UNITED STATES PATENT AND TRADEMARK OFFICE

APPLICATION NO.	FILING DATE	FIRST NAMED INVENTOR	ATTORNEY DOCKET NO.	CONFIRMATION NO.
09/737,279	12/14/2000	Seiji Hiroshima	MITS:024	7933

Office Action Summary

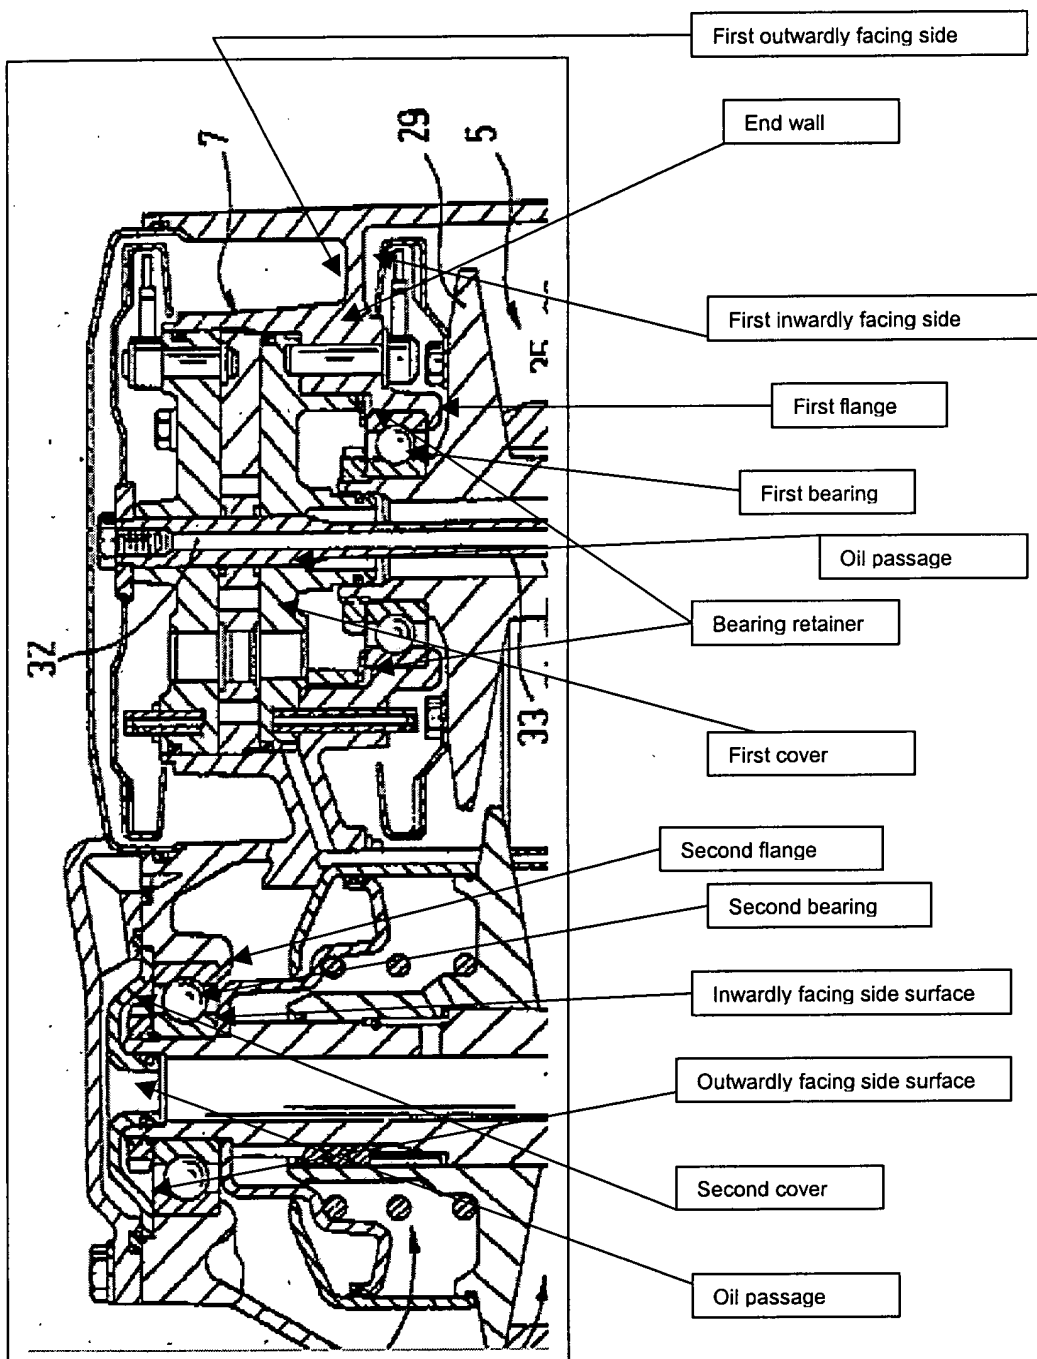
Re: claims 1 and 3. Svab et al. show in the figure a continuously variable transmission comprising : a CVT mechanism comprising: a primary shaft 17 having a primary pulley 5, a secondary shaft shown connected to element 9 having a secondary pulley 9, and an endless belt 36 wound on the primary pulley and the secondary pulley, a housing in the area of the lead arrow of number 7 that accommodates the continuously variable transmission mechanism, the housing having an end wall as labeled on pg. 4 of this Office Action that is formed with a first bearing mounting hole as

shown through which one end portion of one of the primary shaft and the secondary shaft penetrates, the end wall having a first outwardly facing side as labeled and a first inwardly facing side as labeled opposite to the first outwardly facing side around the first bearing mounting hole, the first inwardly facing side being located closer to the primary or secondary pulley associated with the one end portion of the one shaft than the first outwardly facing side, a first bearing as labeled fitted in the first bearing mounting hole and allowing the one shaft to be supported rotatably by the end wall, a first flange as labeled extending radially from the first inwardly facing side toward the first bearing mounting hole, a bearing retainer as labeled provided on the first outwardly facing side of the end wall and projecting radially inwardly toward the first bearing mounting hole, and engaging the first bearing to pinch the first bearing against the first flange as shown, and a first cover as labeled connected to the housing and covering the one end portion of the one shaft and the bearing retainer.

Re: claims 2 and 10. Svab et al. show in the figure the limitation wherein the end wall is formed with a second bearing mounting hole as shown through which one end portion of the other of the primary shaft and the secondary shaft penetrates, the CVT further comprising: a second bearing as labeled on pg. 4 that is fitted to the second bearing mounting hole and allows the other shaft to be supported rotatably by the end wall, an urging member or spring of element 8 that is in contact with (or provided on indirectly), via the element abutting the left side of the spring, an inwardly facing side surface of the second bearing as labeled, the urging member being elastically deformable in an axial direction of the primary shaft and the secondary shaft, and a second cover as labeled that is connected to the housing and covers the one end portion of the other shaft, and cooperates with the urging member to pinch the second bearing in the axial direction.

Re: claims 4-6. Svab et al. show in the figure the limitation wherein the depth of the first bearing mounting hole (particularly the distance between the inside of the first flange and the first outwardly facing side portion of the end wall shown to the right of the top portion of the bearing retainer), which extends in an axial direction of the primary shaft and the secondary shaft, is shorter than the thickness of the first bearing as shown, which extends in the axial direction, and wherein the first bearing receives urging force in a direction from the bearing retainer to the first flange and is thereby in contact with the first flange as shown.

Re: claims 7 and 8. Svab et al. show in the figure the CVT further comprising a second flange as labeled on pg. 4, the end wall having a second outwardly facing side

and a second inwardly facing side opposite to the second outwardly facing side around the second bearing mounting hole, wherein: the second flange extends radially from the second inwardly facing side toward the second bearing mounting hole, the second cover contacts the second outwardly facing side of the end wall and an outer side surface of the second bearing in the same plane as shown; the depth of the second bearing mounting hole, which extends in the axial direction is shorter than the combined thickness of the second bearing and the urging member in a free state, which combined thickness extends in an axial direction, and the second bearing receives urging force in a direction from the urging member (via the element abutting the left side of the spring of element 8) to the second cover and is thereby in contact with the second cover as shown.

Re: claim 9. Svab et al. show in the figure the limitation wherein each of the first and second covers has an oil passage as labeled (Examiner notes that the passages may be considered to be oil passages since element 7 is an oil pump that dispenses oil) through which operation oil is supplied to the CVT (via the unsealed crevices).
